**Town of Nags Head Planning Board
Nags Head Municipal Complex Board Room
Tuesday, November 19th, 2024; 9:00 a.m.**

Subject: Site Plan Review, 105 W. Seachase Drive

Purpose/Request: Construction of an approximately 8,305 square foot Dare County Emergency Management Services (EMS) station and all associated site improvements. Note that "Future Additions" are not included as part of the Site Plan Review.

1
A2.1
FRONT ELEVATION
1/8" = 1'-0"

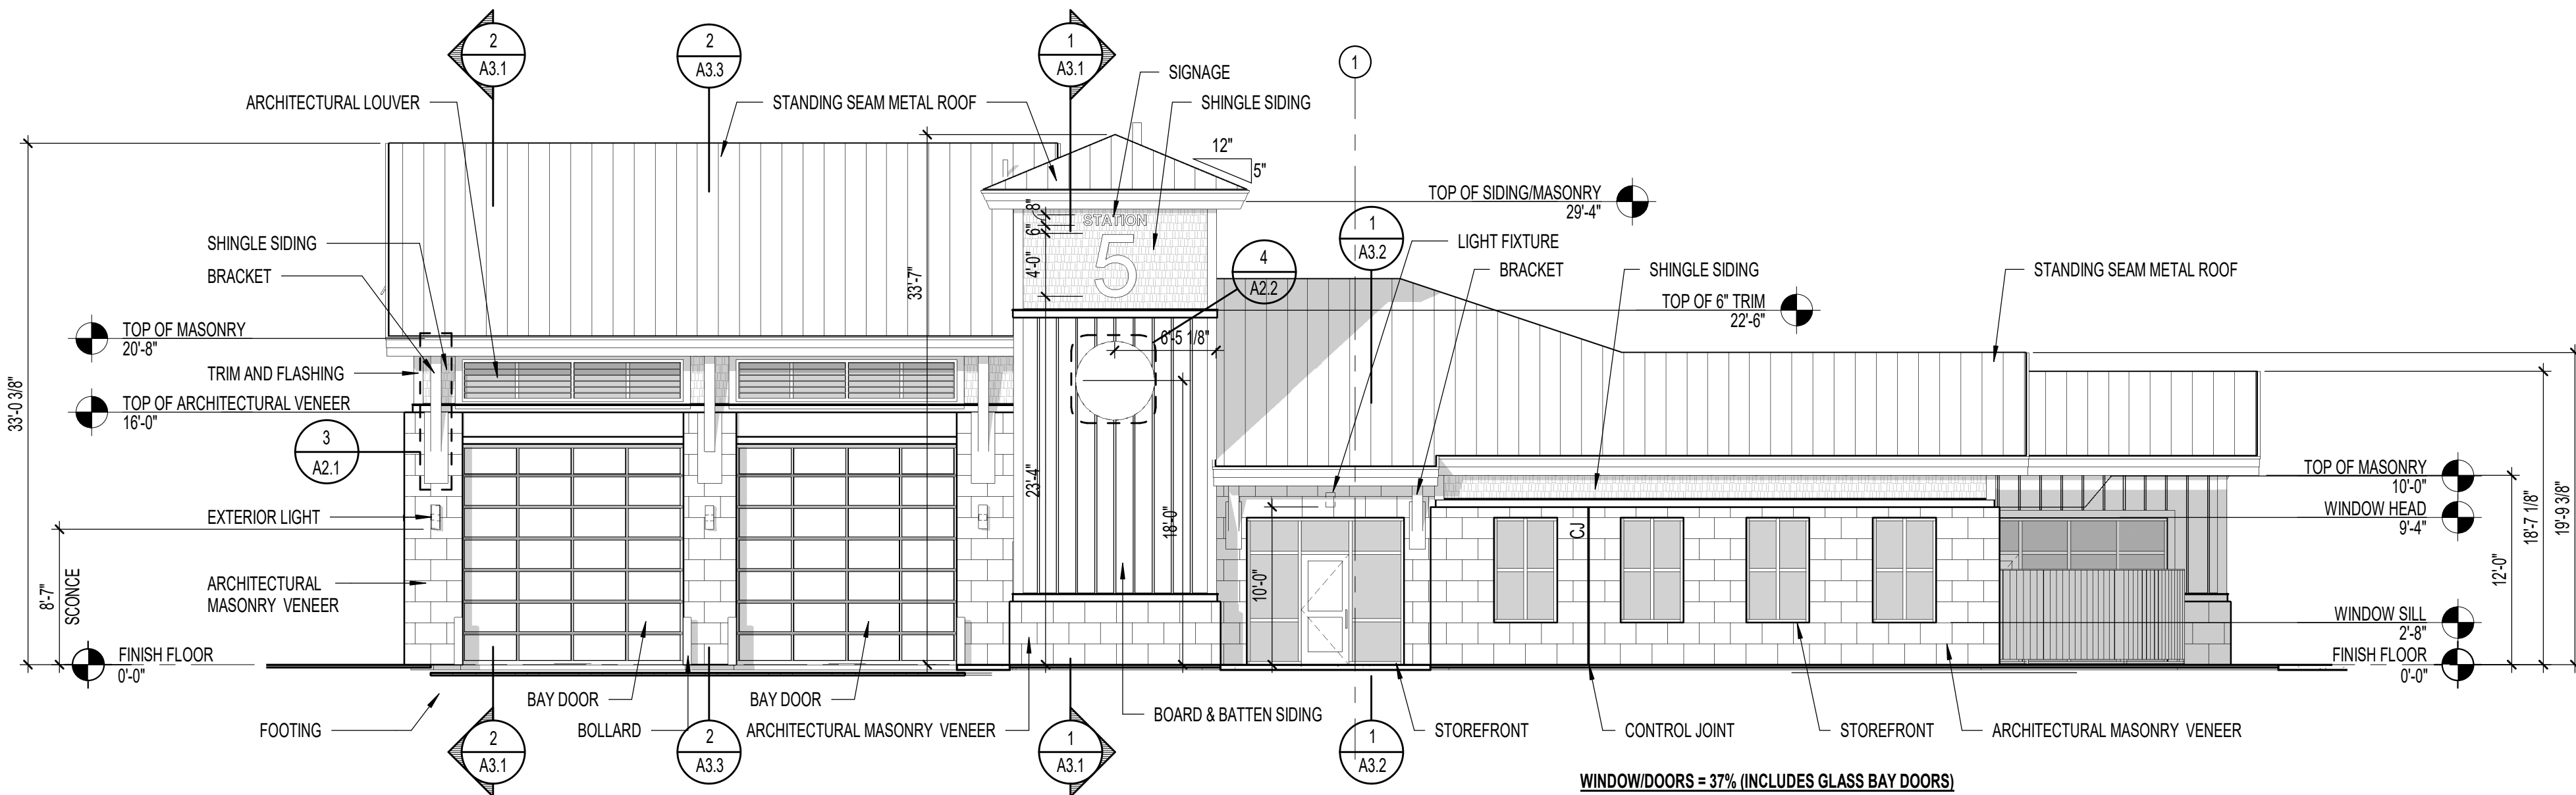
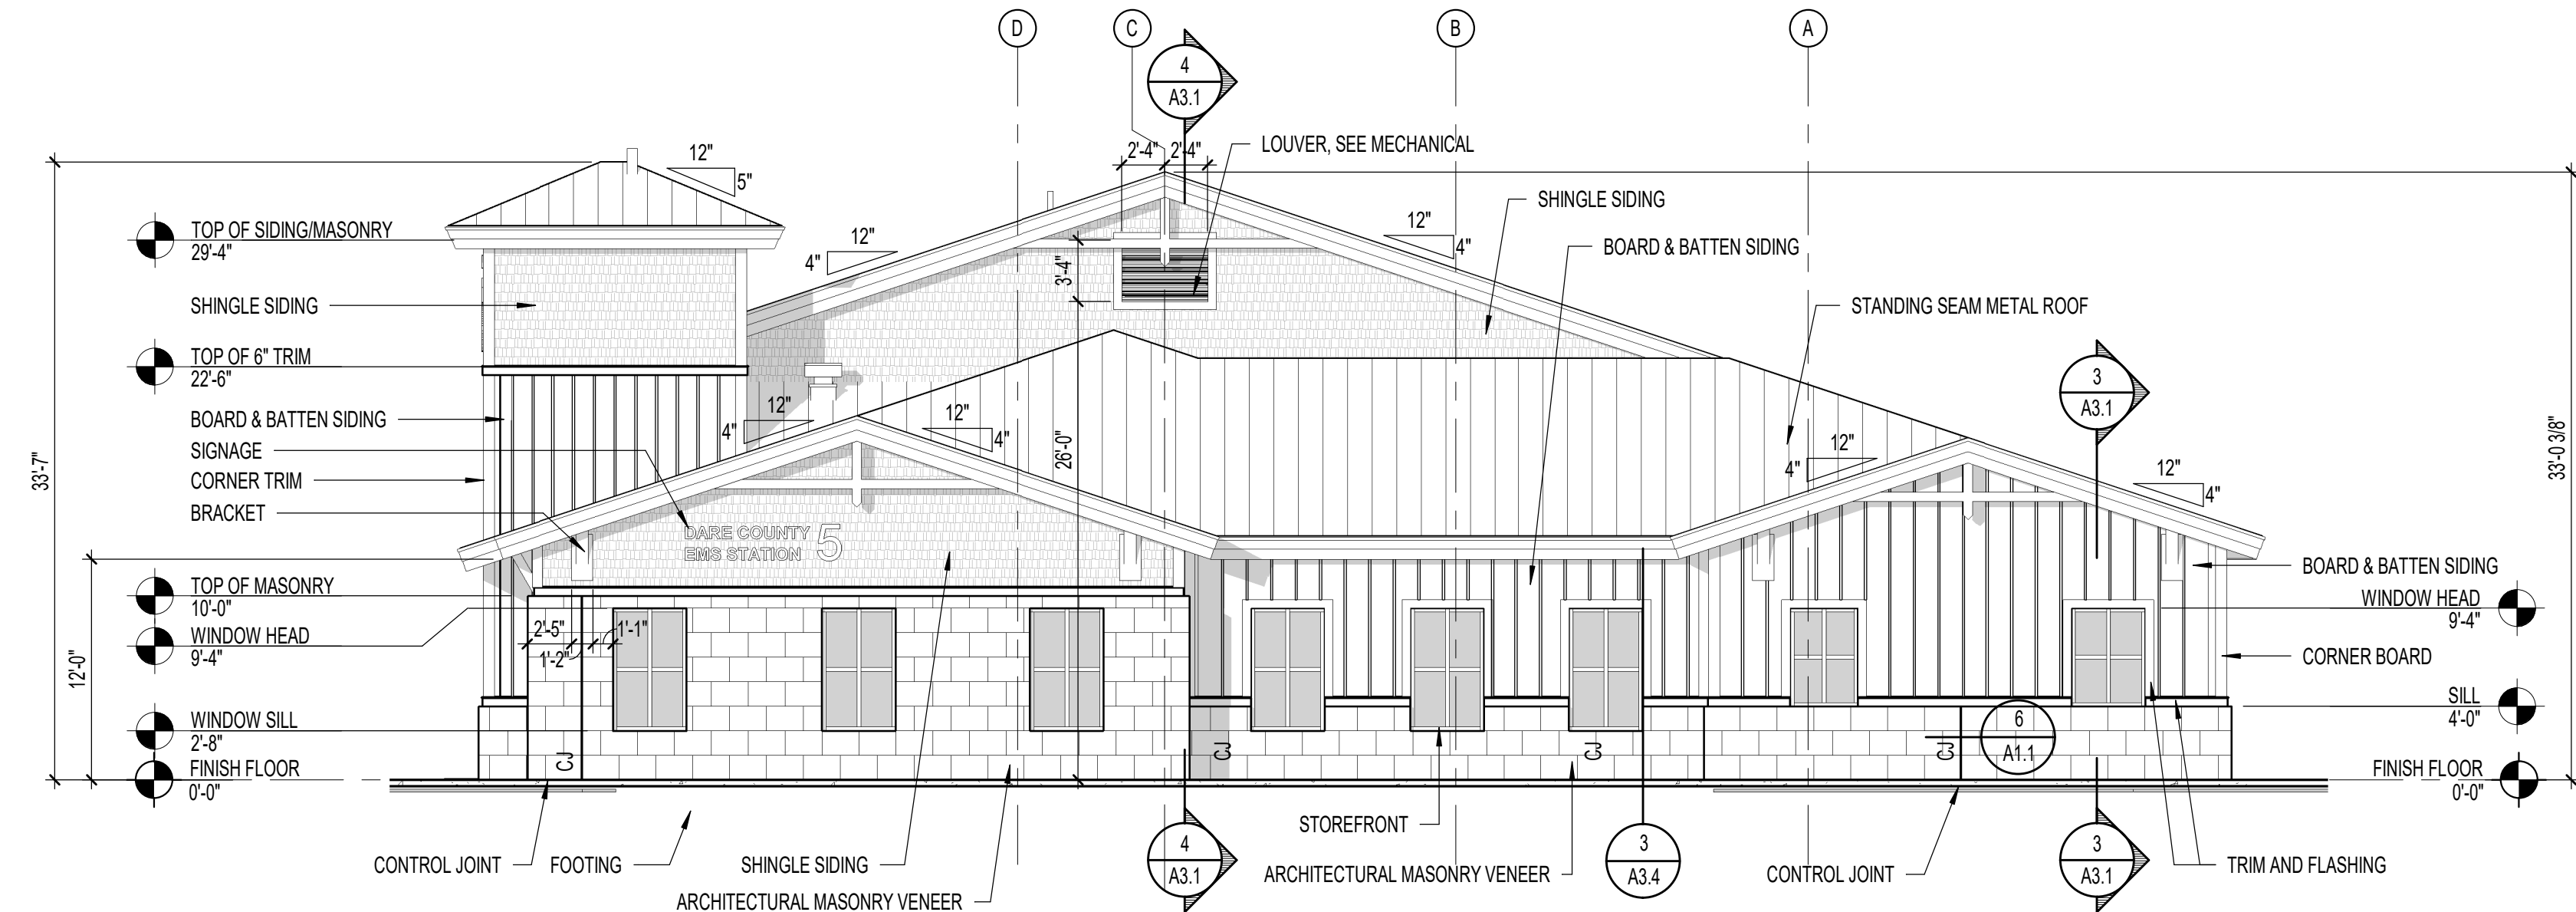
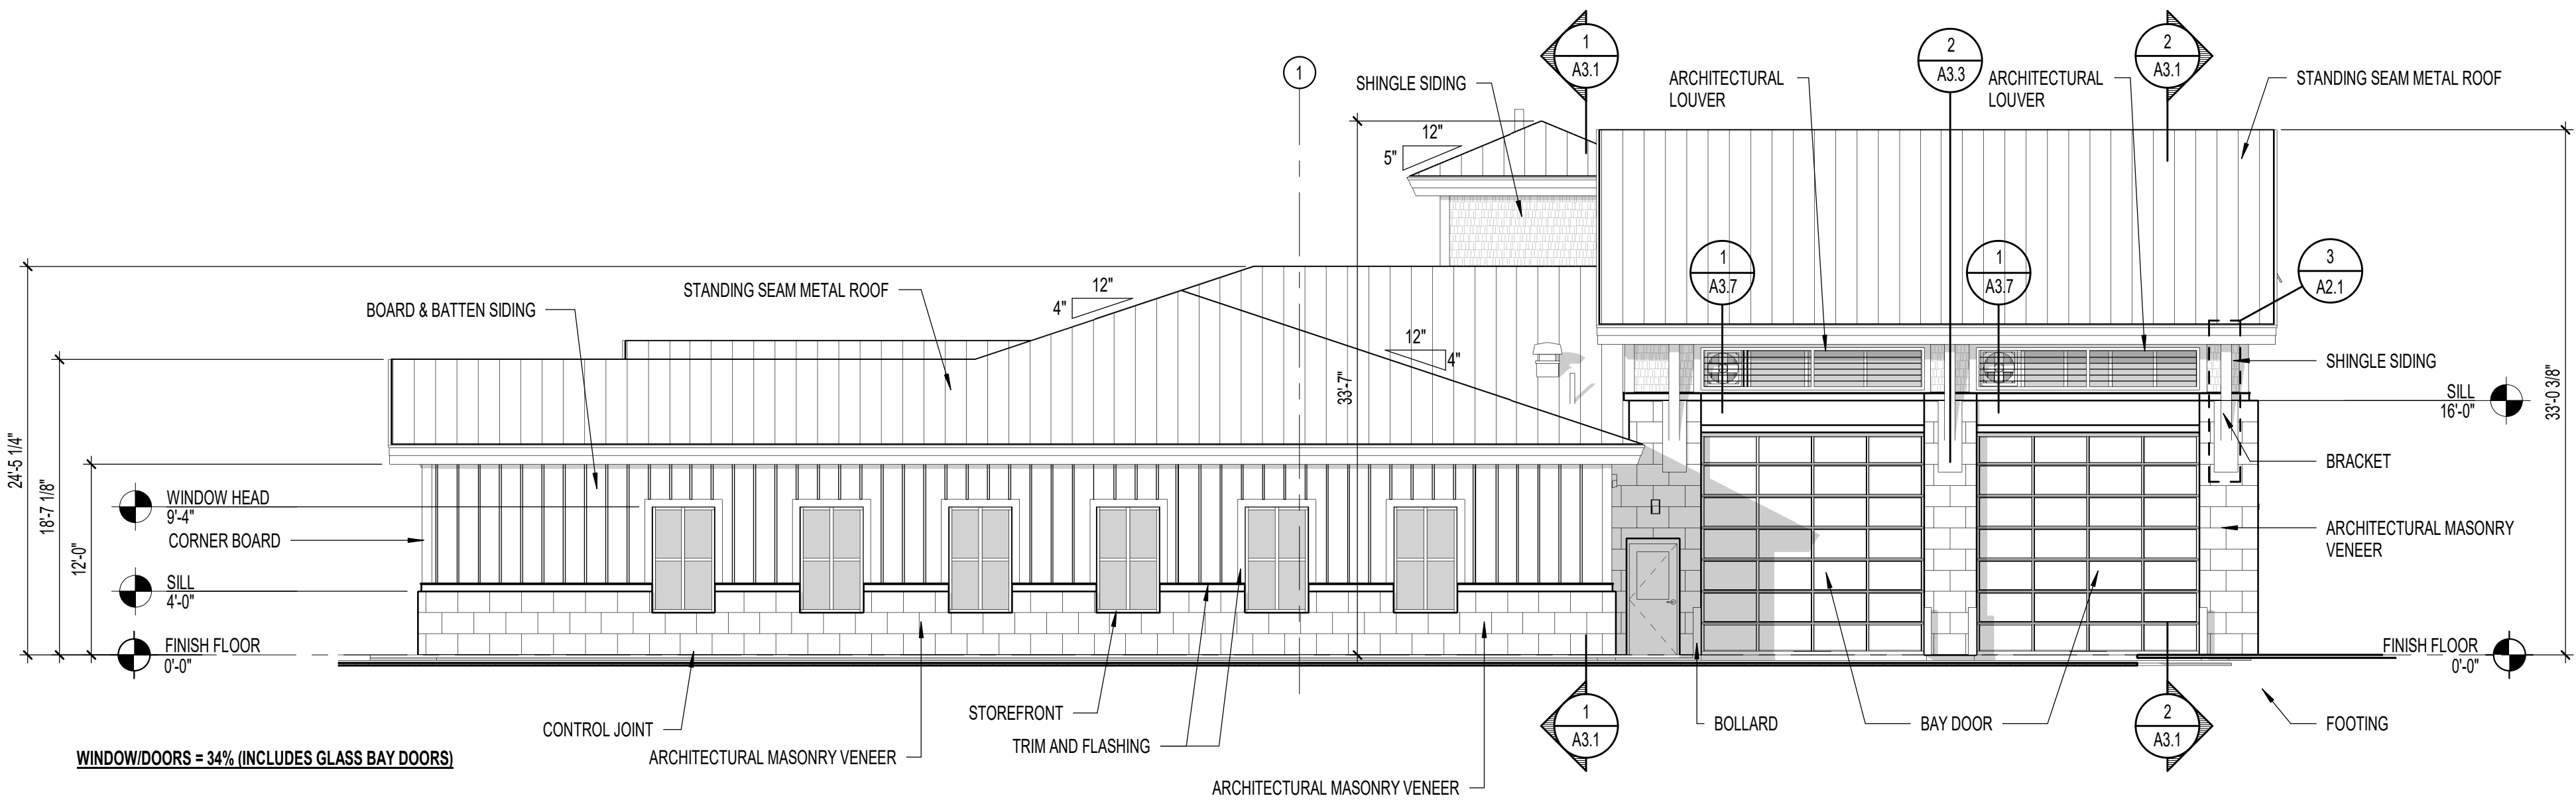
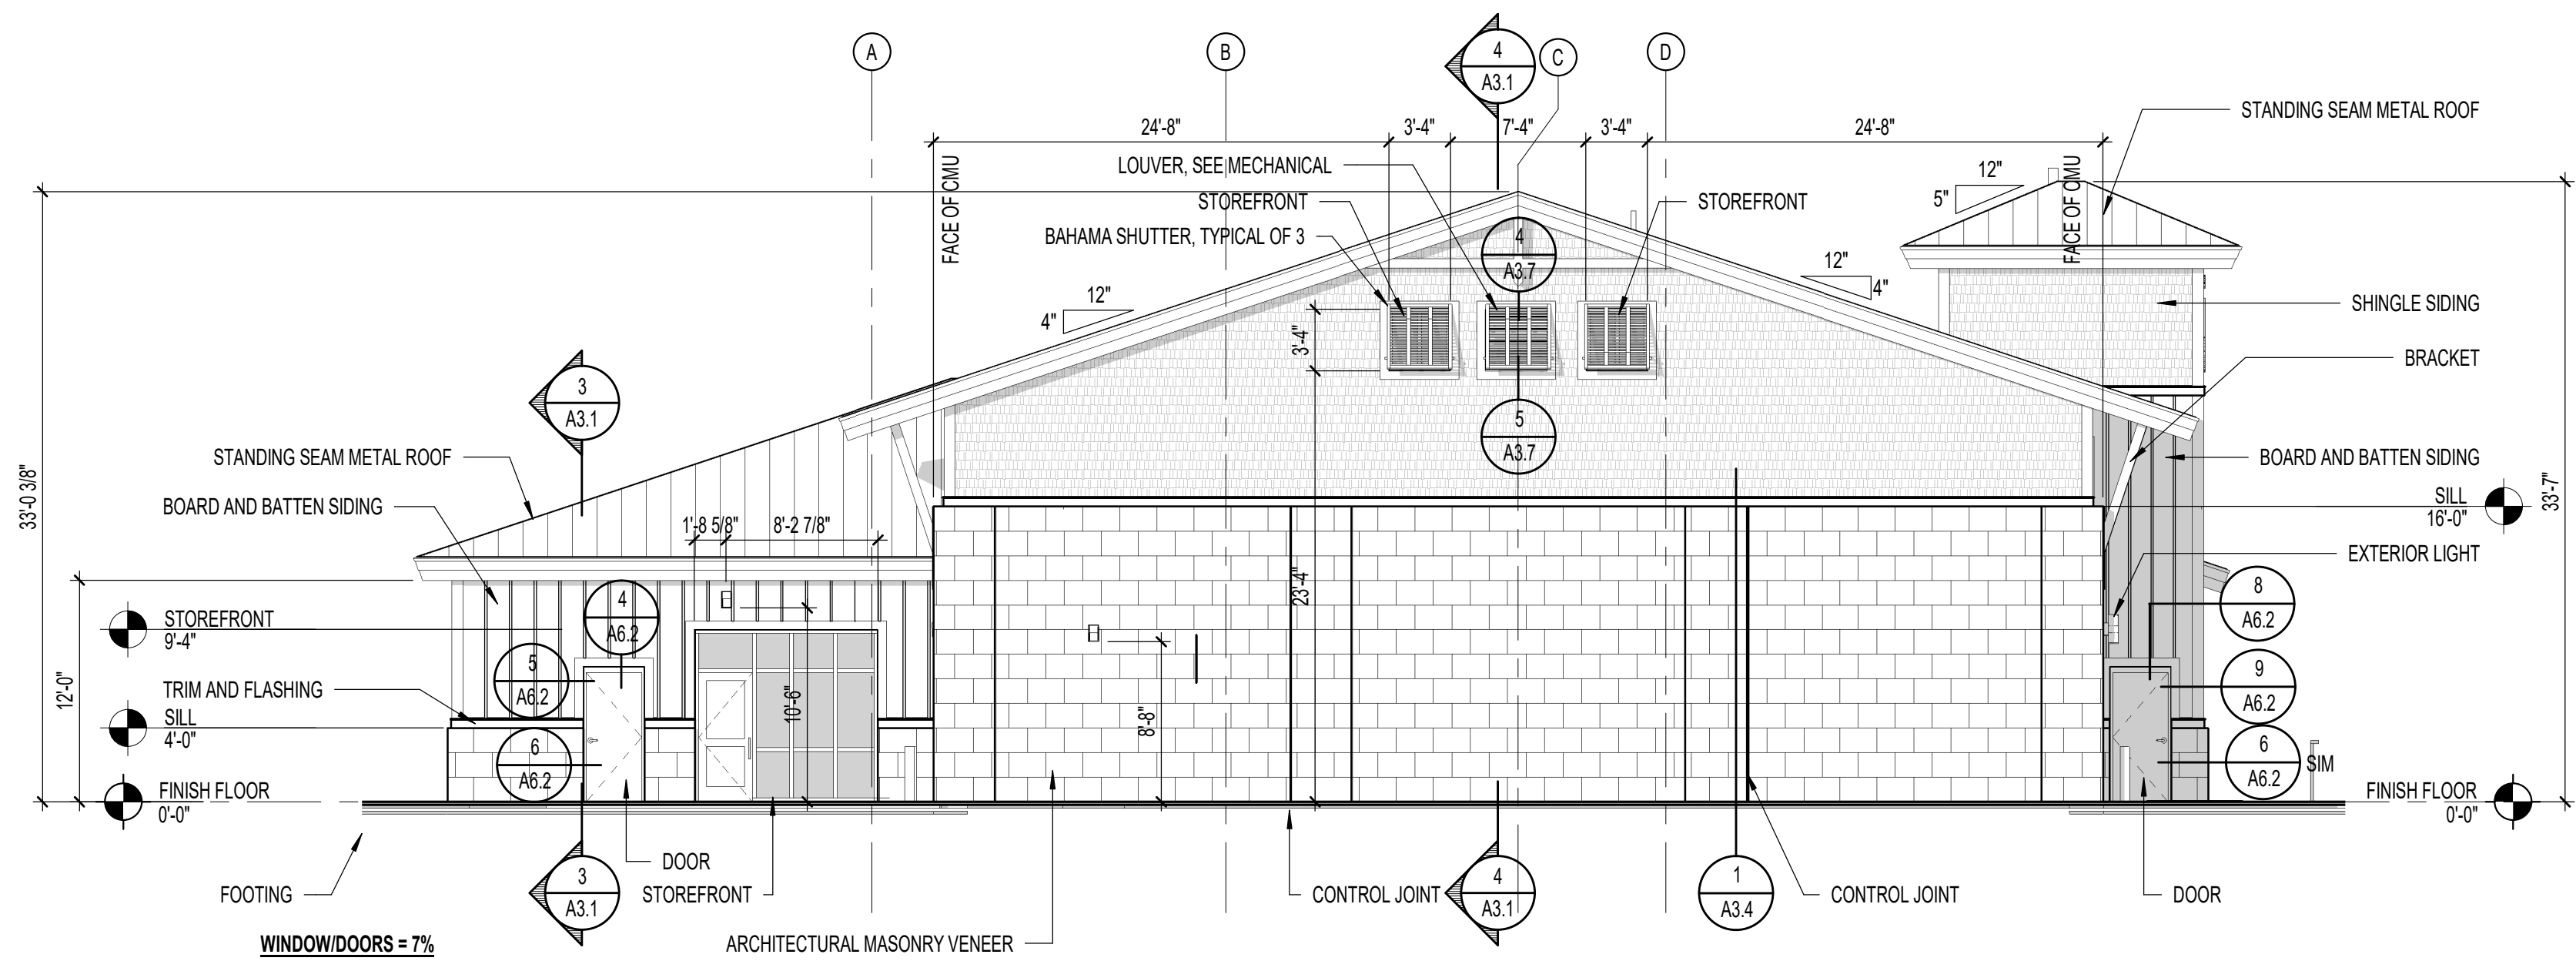
- Architecture Design Standards: Section 10.82 of the UDO, Applicability, states that Commercial Design Standards shall apply to all building construction or remodeling projects requiring a special use permit or site plan review. This project must adhere to the Commercial Design Standards set forth within Part VI of the UDO. As proposed this project will comply with standards set forth in Division II – Building Design including a human scale design, various roof articulations including a watch tower, residential style window, exterior masonry with board and batten and shingle siding, workable shutters, and gable brackets.
